Table 2 - An Alternative Design Approach

Refusal Reason	Alternative Design Approach
----------------	-----------------------------

Integrating the Local Heritage Place

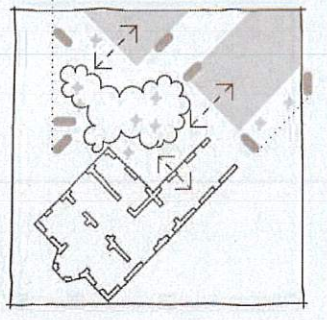
2 The proposal does not meet Performance Outcomes 1.1, 1.2, 1.3, 1.4, and 1.5 as the proposed built form both dominates and negatively impacts the existing local heritage place through massing, setbacks, scale, design, materials and architectural features.

AND ISOLATION

STILL SUBSTANTIALLY THE SAME

The proposed design focuses on the integration of the Local Heritage Place, utilising it as a design tool by referencing its datum height in the 'plinth'. The proportions, setbacks, angles and material palette are designed to be sympathetic to the Local Heritage

The existing building's use will also remain hospitality, to ensure the corner of the site is activated. Landscaping of the rear courtyard provides further integration of the Local Heritage Place and the new building with alfresco area, provision of a large Jacaranda tree and landscaped open space and
